EXHIBIT A

Subject: Request for Approval - Work Plan – Use Attainability Analysis – Determine if Naturally Occurring Thermal Conditions Prevent Attainment of Coldwater Aquatic Life Use in the Perennial Reach of Sandia Canyon Assessment Unit (9000.A_047) – Water Quality Segment 20.6.4.126

**Work Plan – Use Attainability Analysis –
Determine if Naturally Occurring Thermal
Conditions Prevent Attainment of Coldwater
Aquatic Life Use in the Perennial Reach of
Sandia Canyon – Water Quality Segment
20.6.4.126**

Use Attainability Analysis Work Plan – Determine if Naturally Occurring Thermal Conditions Prevent the Attainment of Coldwater Aquatic Life Use in the Perennial Reach of Sandia Canyon Assessment Unit (9000.A_047) – Water Quality Segment 20.6.4.126

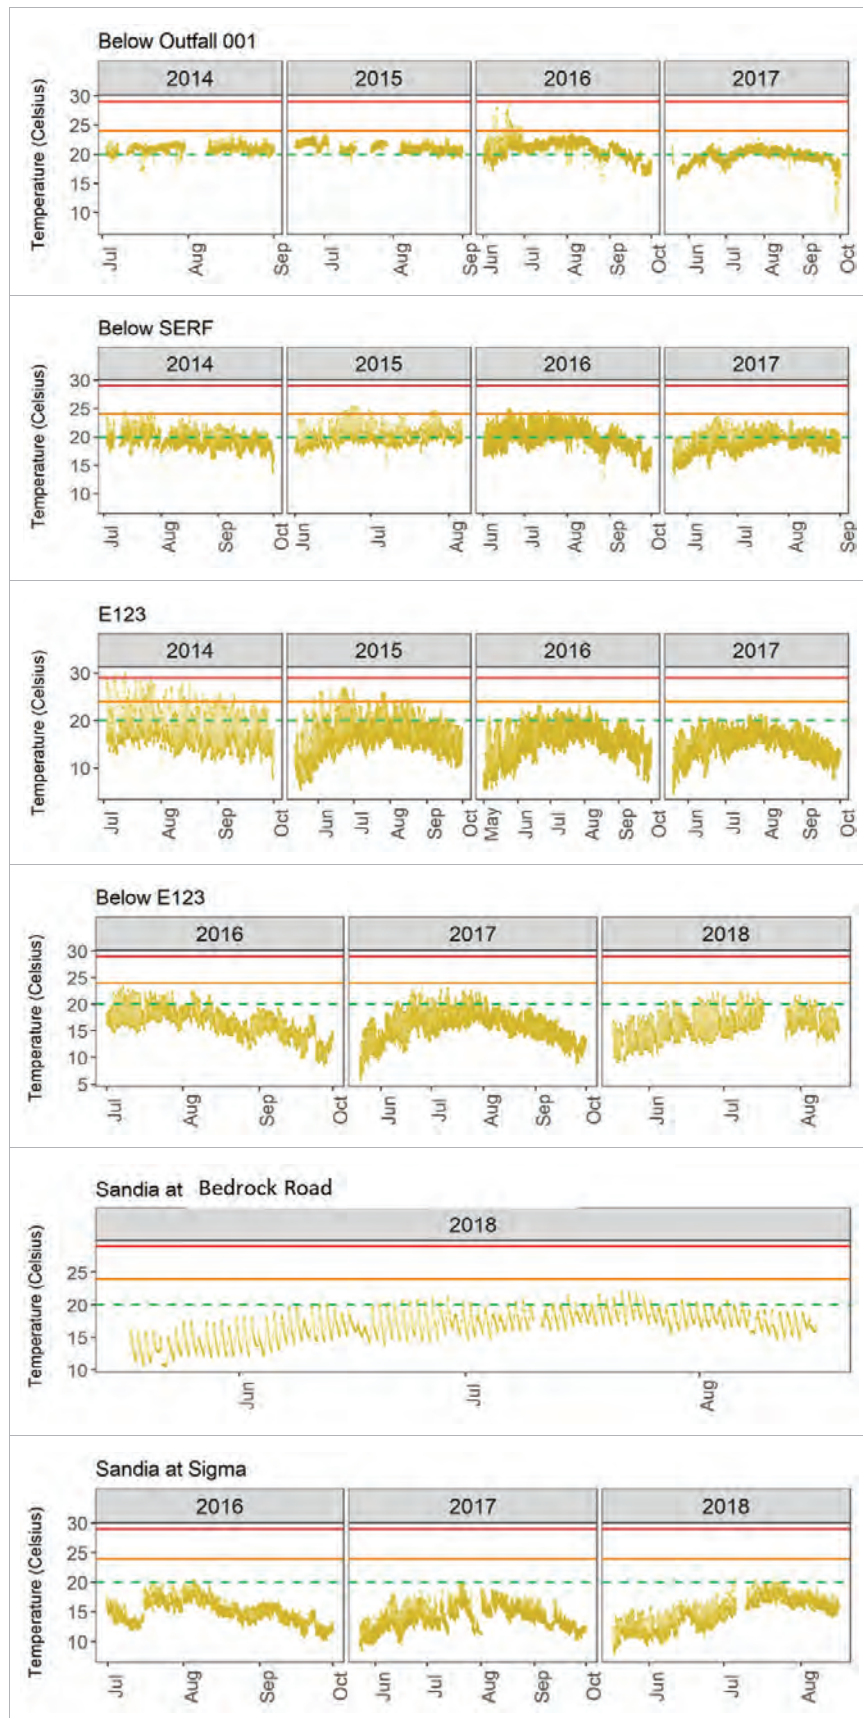
- 6) Note should be added to Figure 3 caption, p. 13: “Note that the coldwater 6T3 threshold is presented for reference only (thermograph data is from instantaneous measurements and Figure 3 does not represent attainment or non-attainment of the calculated coldwater 6T3 criterion).”

Figure 2. Upper Sandia Canyon Assessment Unit Study Area.

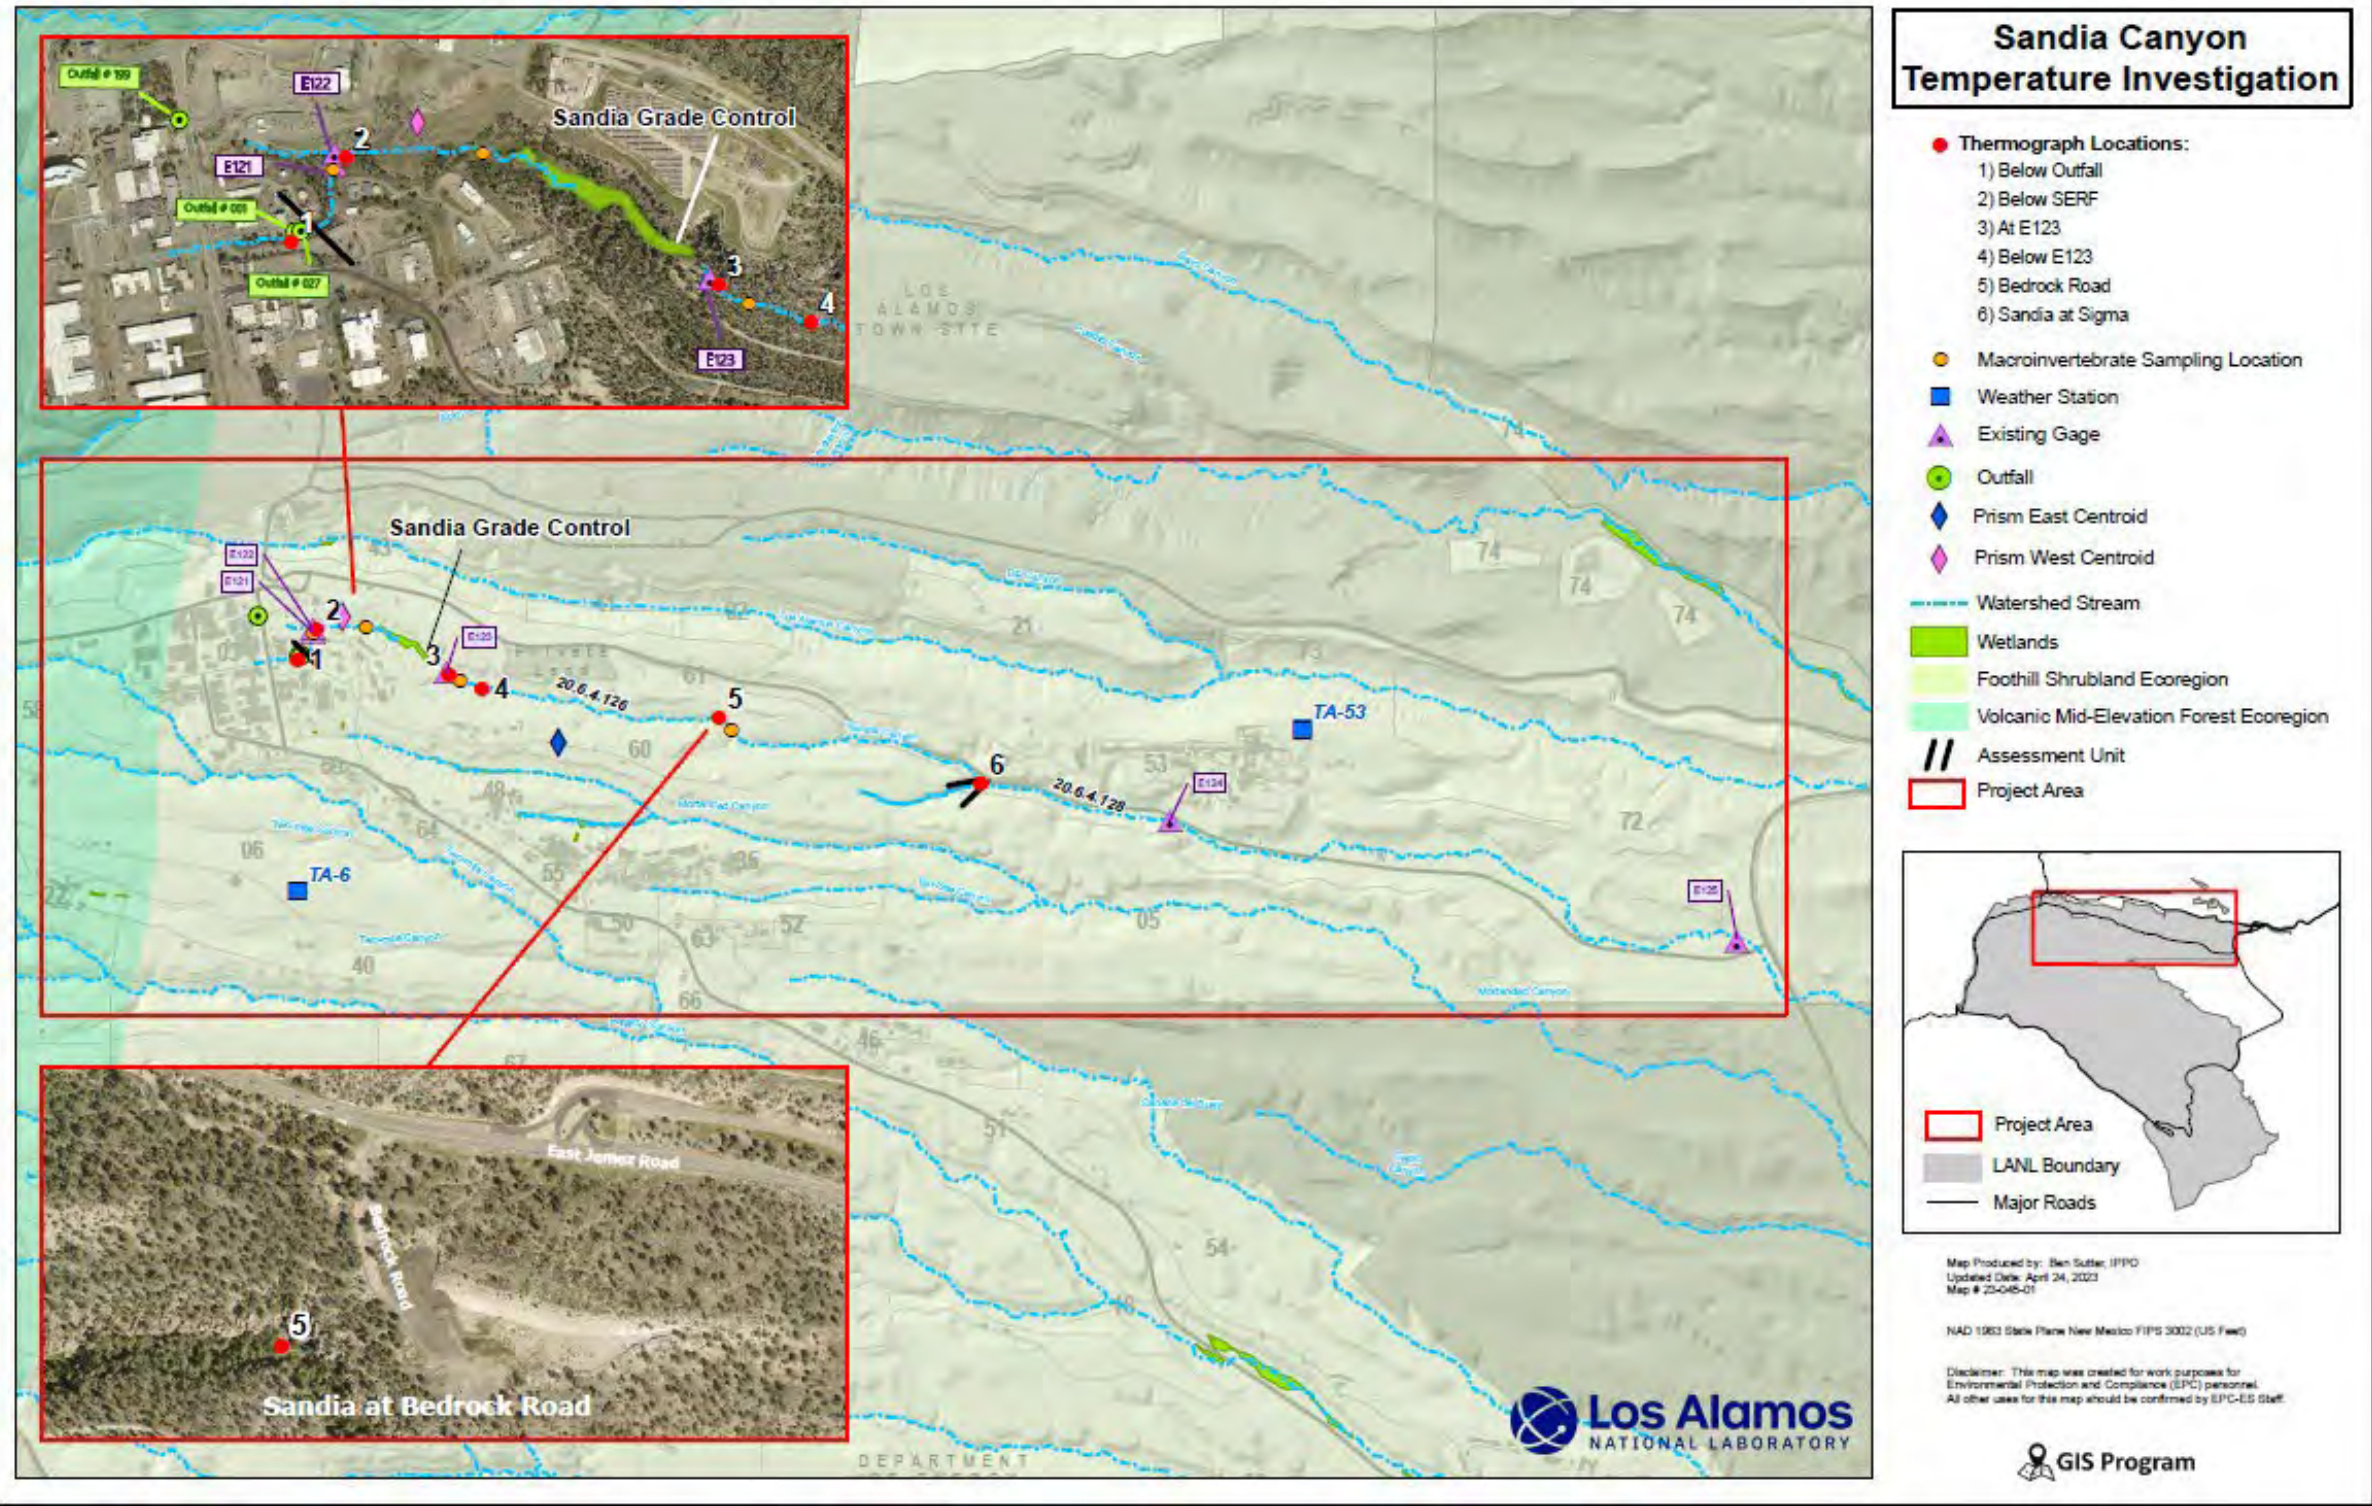
8. The Department requests the map with sampling locations (Figure 2) include the centroids for the two 800-meter Parameter-elevation Relationships of Independent Slopes Model (“PRISM”) cells (i.e., Upper Sandia AU-east and -west) used in the AWTC model.

The map with sampling locations (Figure 2) has been updated to show the centroids for the two Parameter-elevation Relationships of Independent Slopes Model (“PRISM”) cells (i.e., Upper Sandia AU-east and -west) used in the AWTC model. These centroids are located at the following coordinates:

Figure 1. Upper Sandia Canyon assessment unit. GPS coordinates are provided in Appendix B.

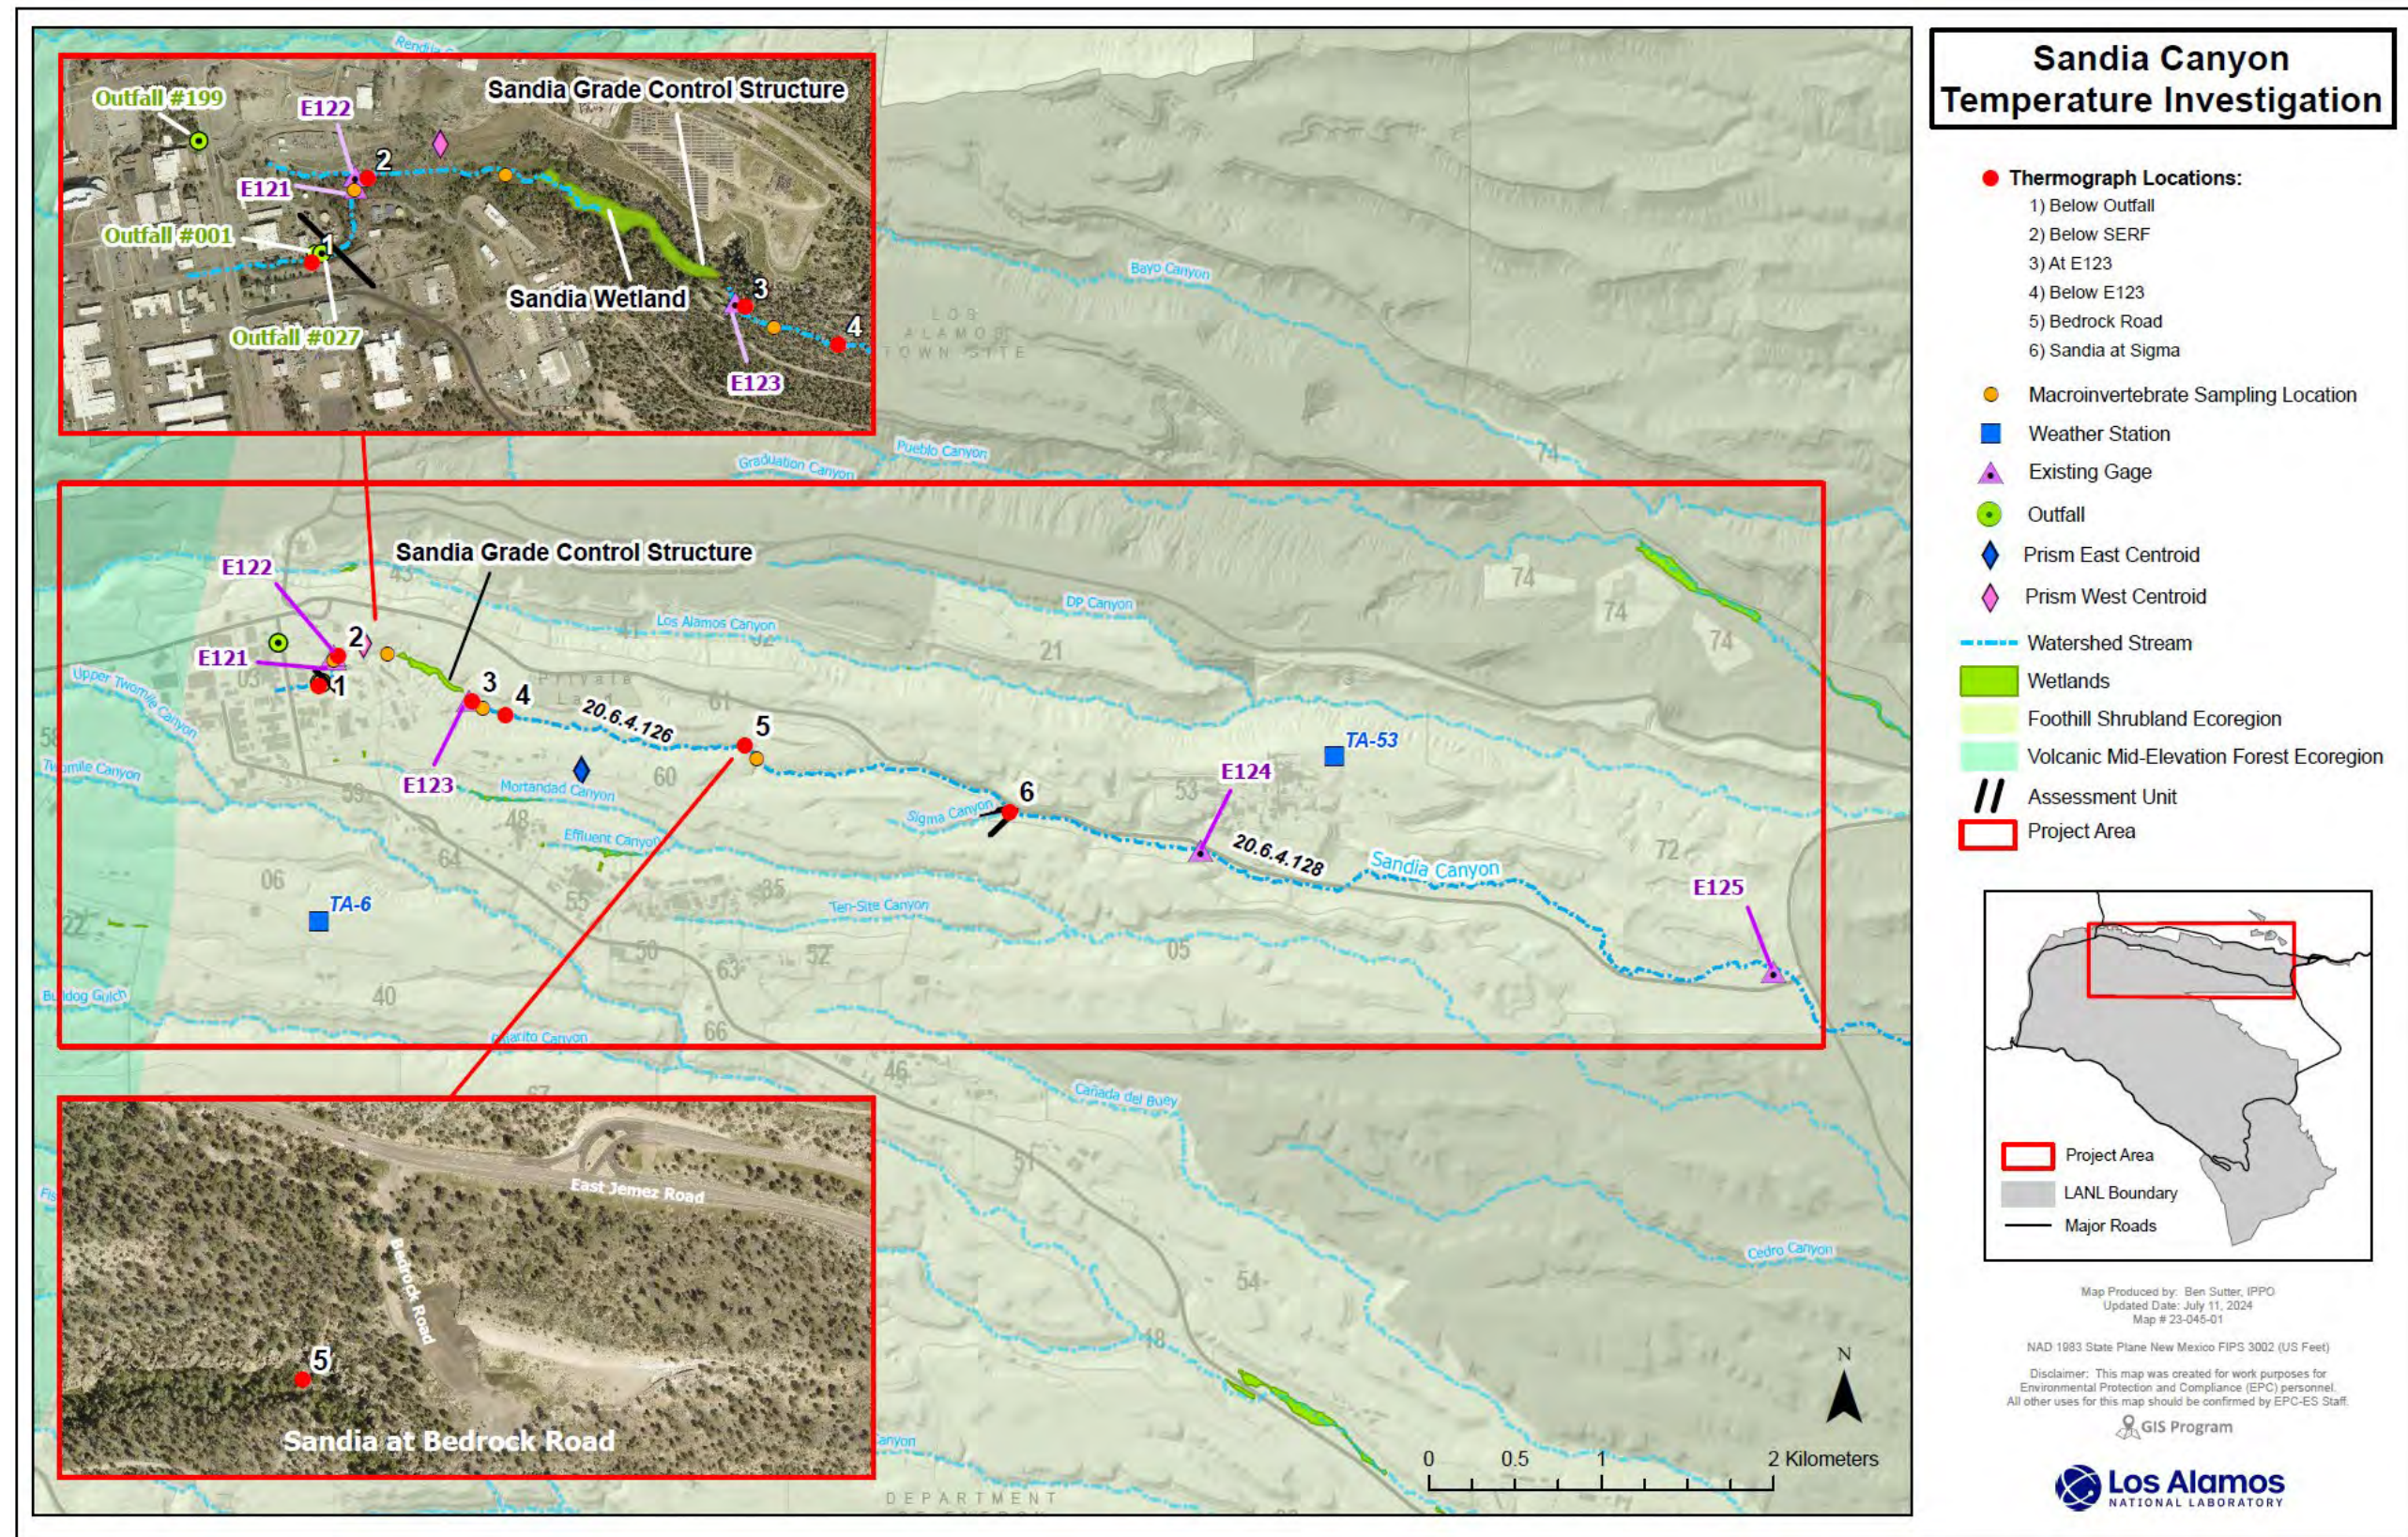
- 2) Figure 1, p. 4 (Attached) – updated to include scale, north arrow, and clarify labeling
- 3) Figure 2, p. 5 (Attached) – updated to include scale, north arrow, and clarify labeling
